**SUBJECT: Rear Auxiliary Lamp Compliance**  
**MODEL YEARS: 2024 & Beyond**  
**AFFECTED MODELS: UU Model THREE**  
**INITIATION DATE: 11/16/2023**  
**REVISION: 11/28/2023**

Fig 1

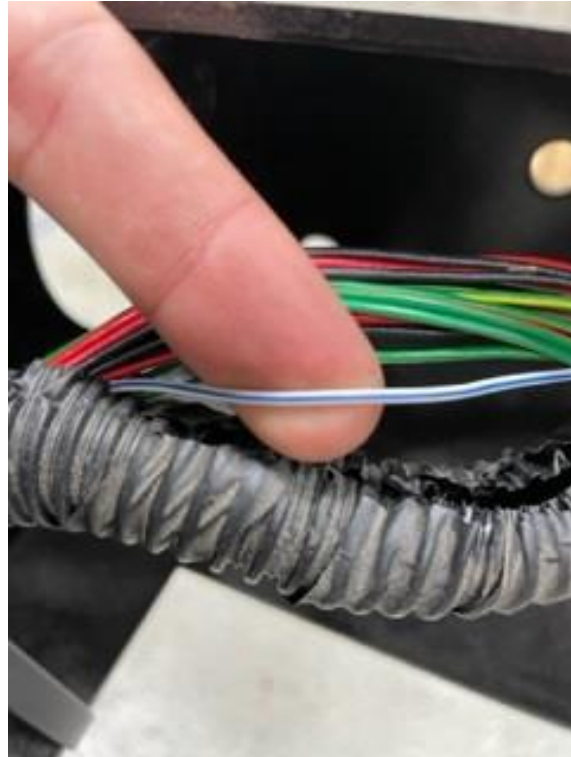
**Description of Concern:** The current Turn Signal / Headlamp stalk on the left side of the steering column offers a twist switch to enable for a Front or Rear Fog Lamp feature. The second detent enables the Rear Fog Lamp feature and Cluster Symbol (see Fig 1 & 2). Federal regulation (FMVSS) compliance prohibits the use of Rear Fog Lamps on DOT approved vehicles. This feature should not be enabled on the completed vehicle upfit.

**Solution:** Federal regulations (FMVSS) prohibit the use of Rear Fog Lamp feature regardless of the applied tail lamp units. The Second Stage Manufacturer (Upfitter) is responsible to certify their completed vehicle meets all local, state, and federal FMVSS requirements. The Upfitter should use the following tail lamp wiring instructions for disabling the Rear Fog Lamp feature.

Once above Steps 1 & 2 are completed its important to note this procedure will not eliminate the stalk switch function. The switch when activated will still cue the instrument cluster symbol. However, the Rear Fog Lamp feature will be disabled for FMVSS compliance.
